Re: NPDES Permit No. IN0000205
Permit Modification
ArcelorMittal Indiana Harbor, LLC – West
East Chicago, Indiana
Lake County

ARCELORMITTAL INDIANA HARBOR LLC – INDIANA HARBOR WEST

National Pollutant Discharge Elimination System
FACT SHEET
for
ArcelorMittal Indiana Harbor, LLC – Indiana Harbor West
December 2014

3.0 MODIFICATIONS

Figure 1: Outfall Locations

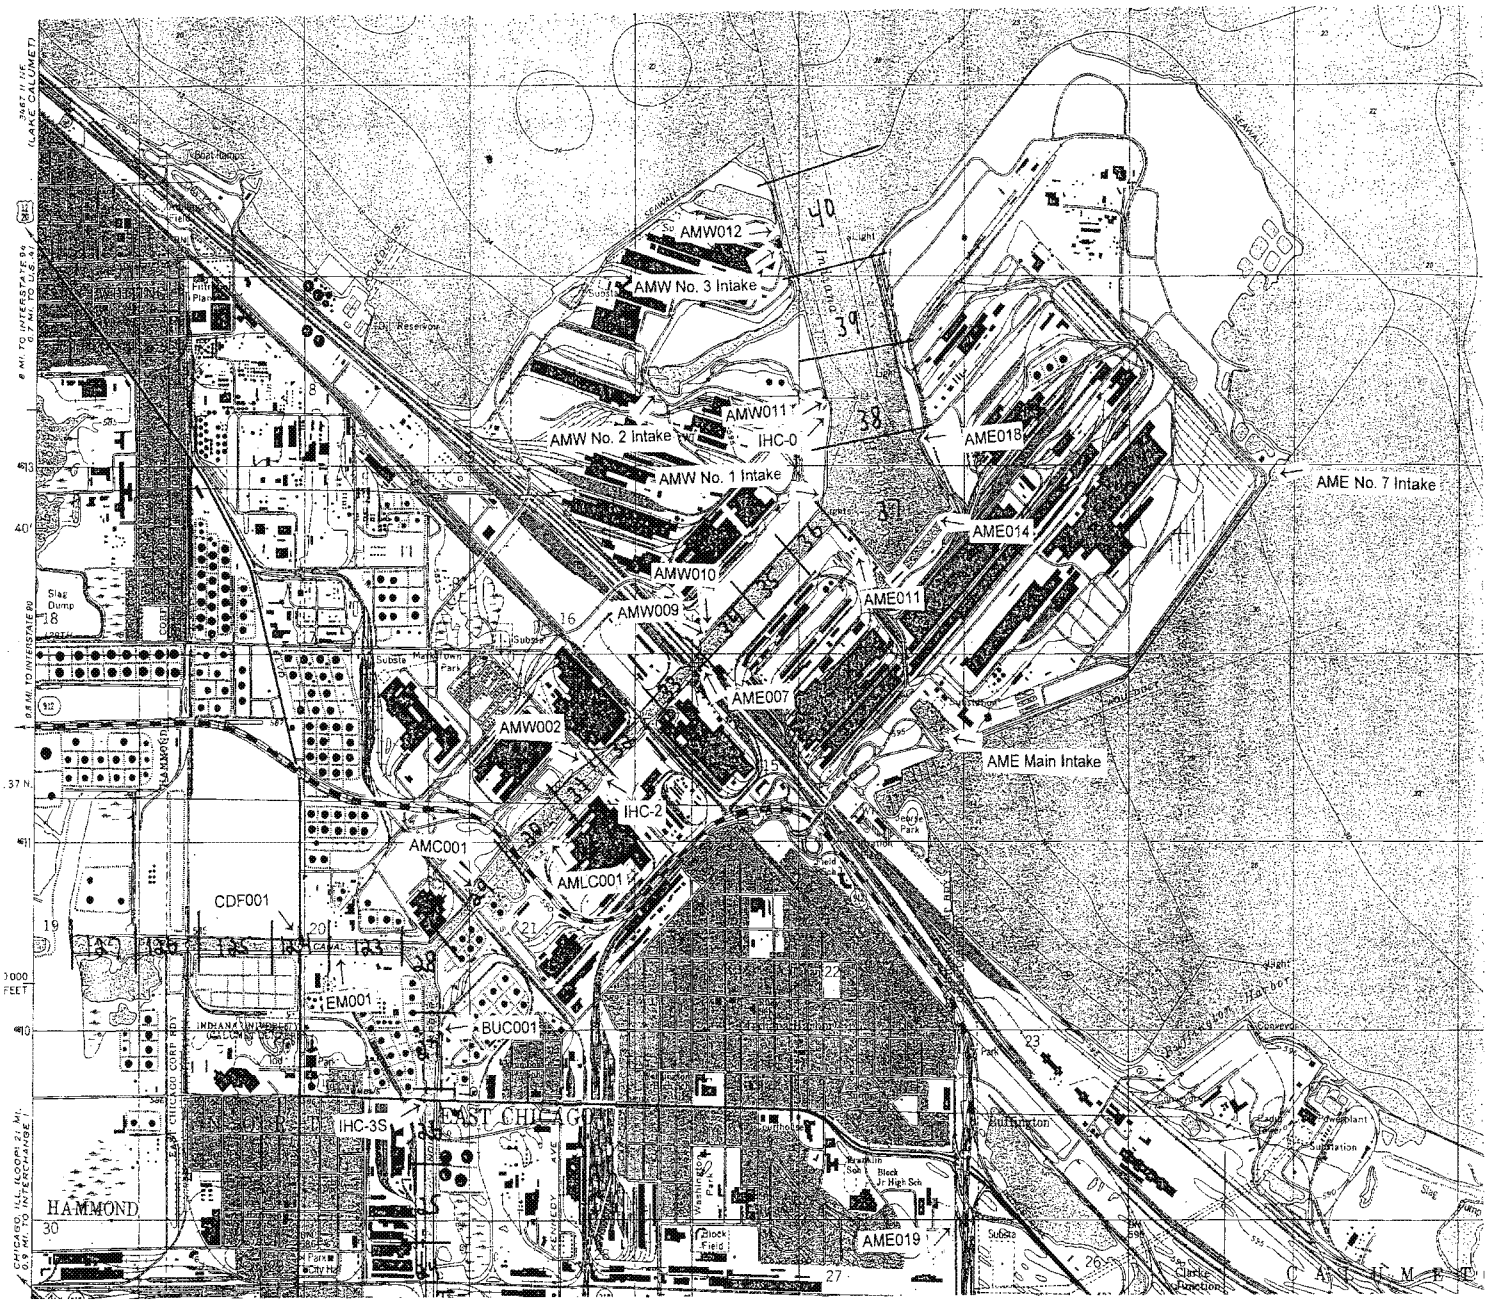
- The receiving stream, identified in Part I.A.8, has been changed from "Lake Michigan" to "the intake channel for the Nos. 2 and 3 water intakes". The facility has maintained since the draft of the December 2011 permit that the location of Outfall 012 is not to the open waters of Lake Michigan. The location of Outfall 012 is behind the break wall to the open waters of Lake Michigan where a long channel allows Intakes Nos. 2 and 3to withdraw water. Outfall 012 discharges to the fore bay of the No. 3 Intake. Furthermore, they have provided dye studies to show that at most, only 12% of the discharge flow from Outfall 012 bypassess the No. 3 water intake and discharges to the intake channel. A new definition of "open waters of Lake Michigan" was added to Indiana regulation at 327 IAC 2-1.3-2(30) in 2012 as part of the statewide antidegradation rulemaking. Based on the new definition, IDEM has determined that the discharge from Outfall 012 is not to the open waters of Lake Michigan. A map showing the location of Outfalls 012 (AMW012) in relation to the No. 3 Intake has been included as Figure 1.

IDEM conducted a new water quality assessment for Outfall 012 (Attachment A) based on a receiving stream identified as the intake channel for the Nos. 2 and 3 water intakes, using a reduced effluent flow and using additional effluent monitoring data collected since the permit renewal. As a result, vanadium and ammonia no longer showed a Reasonable Potential to Exceed (RPE) Indiana Water Quality Standards. Therefore, they were removed from Part I.A.8 of the permit.
